TECHNICAL NOTE 1

DATE:	14 May 2021	CONFIDENTIALITY:	Confidential
SUBJECT:	Lyncombe Residents Parking Zone Consultation Responses		
PROJECT:		AUTHOR:	Jon Lewis
CHECKED:	Neil Terry	APPROVED:	Paul Garrod

Figure 1 – Lyncombe Residents' Parking Zone

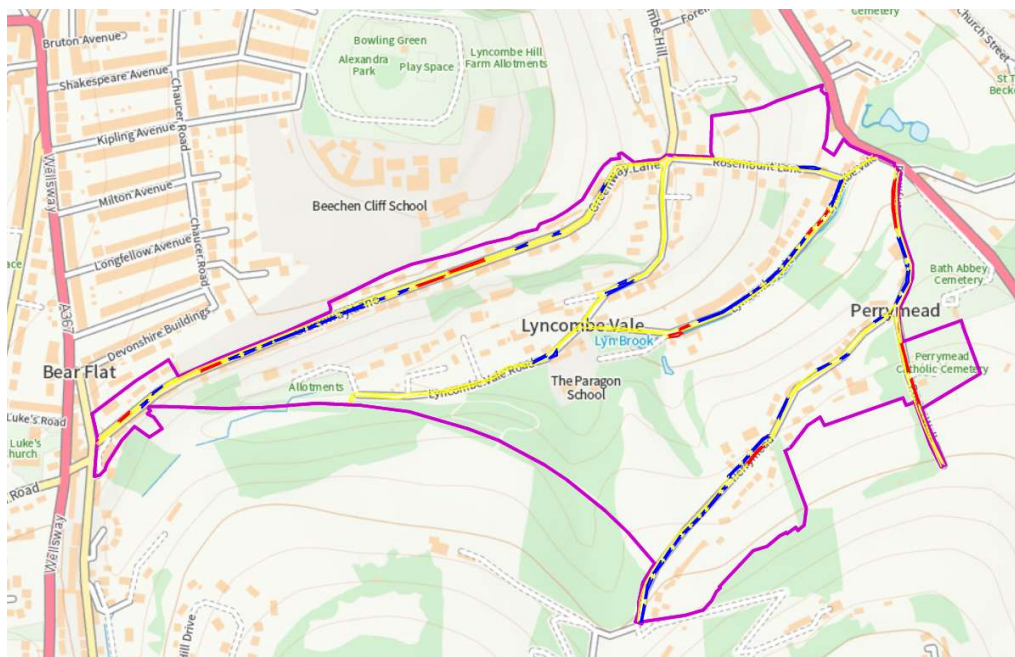
- Permit holder parking outside number 11 Greenway Lane - this will severely impede ability to access drive to 9 Greenway Lane when reversing from the direction downhill of travel. Furthermore, any vehicles wanting to pass this section of parking would block access.
- Dual use 3 hour limited and permit holders outside numbers 5 and 5a Greenway Lane - Would seriously impede traffic flow and be dangerous for road users as no place to pass.
- Outside 20 to 22 Greenway Lane is proposed as a dual use 3 hour limited and permit holders - this should be permit use only. – [These bays have now been removed except for the Permit Bay outside number 10 Greenway Lane on the southern side to act as a traffic calming measure along this stretch of highway.](#)

The exit driveway from Lyncombe Vale Farm seems to have been included in a parking zone? – [This has now been amended.](#)

I farm here and need to move around with wide machinery. I have on many occasions had to back up and change plans because I can't get past. The main sections of concern for me are Popes walk, by the graveyard and the crest of the hill around street light 7. - [The dual use LW and Permit bays on Popes Walk have been set back onto the pavement area to provide sufficient width of highway to allow larger vehicles to pass unobstructed. The narrower pinch points have also been covered by No Parking At Any Time restrictions.](#)

We have an electric vehicle and have to charge it outside our garage using a safety mat across the pavement. There is no other way of charging electric cars in Bath unless you have off street parking. As it stands, the RPZ will make it impossible for us to charge our car. We require a parking bay outside our (un-used) garage at 18 Greenway Lane, or at least the retention of the single white line. – [A Permit Holder Only parking bay has now been included on the plan in this location at the local Ward Members request.](#)

The permit-only parking outside Woodstock and Cloisters Cottage is on the opposite side of the road to where cars currently park. If this is enacted it will significantly reduce the available spaces, and also potentially block access to some properties. – The bay has now been moved to the southern side of Perrymead to match the existing parking arrangements.

The permit parking zone outside Hedgerow, Glynmead, and Burnbank seems to block access to driveways. – This has now been picked up and access has been kept clear.

The permit parking zone outside Yew Tree Villa appears to block access to a driveway. - This has now been picked up and access has been kept clear.

The junction between Rosemount lane and Lyncombe Vale can be quite dangerous. The view from Rosemount Lane west along Lyncombe Vale is badly restricted by any car parked on Lyncombe Vale close to the corner. The map shows parking allowed right up to the corner. I do believe for reasons of safety, parking up to the junction of Lyncombe Vale and Rosemount Lane should not be allowed. – [A 2 metre section of No Parking At Any Time restrictions has been introduced south of this junction to improve visibility and sight lines when exiting from Rosemount Lane.](#)

The Map appears to show Permit holder parking for several vehicles on Lyncombe Vale Rd alongside Hillbrook House south boundary wall. Please reconsider if this location is suitable, as the road narrows at this point and parked cars cause obstruction to larger commercial and service vehicles trying to access the west end of Lyncombe Rd. – [This has now been removed and replaced with No Parking At Any Time restrictions to prevent obstruction.](#)

On the plan it is marked to have parking outside No.3/5 Greenway Lane however the road is not wide enough for this and we have had a fire engine and ambulance stuck. – [This has now been removed and replaced with No Parking At Any Time restrictions to prevent obstruction.](#)

If the proposed resident parking spaces which are currently set against the pavement side of Perrymead, running from properties Woodstock through to Sumela, are switched to the opposite side, ie against the wall where cars currently park and have done so historically to ensure safety of pedestrians and road users alike. – [The bay has now been moved to the southern side of Perrymead to match the existing parking arrangements.](#)

- If confirmation could be given that the proposed resident parking spaces which start outside property Hedgerow allow sufficient clearance of property Woodbine Cottage garage entrance/exit and Hedgerows drive which it does appear to do from the graphic, but I am not sure how detailed the graphic is. – [The proposed Permit Holder bay has been pulled back and the existing No Parking restrictions extended to provide sufficient manoeuvring room when entering / exiting the garage of Woodbine Cottage.](#)

There is no parking problem on east end of Greenway Lane. No yellow lines in front of garages. White lines perfectly sufficient as demonstrated now. By not allowing residents and their visitors to park in front of garages you reduce available parking spaces on street. Not enough provision of resident/visitor spaces on east end of Greenway Lane. There will be less spaces available as a result of scheme. Plenty of other RPZ schemes show you can have even smaller window for time restrictions e.g. 10am-2pm to stop majority of students or commuters from parking. Without these changes unable to support a punitive scheme – [All sections of the highway within a RPZ must be covered by a restriction. We cannot retain free unrestricted parking in front of private garages on the adopted highway.](#)
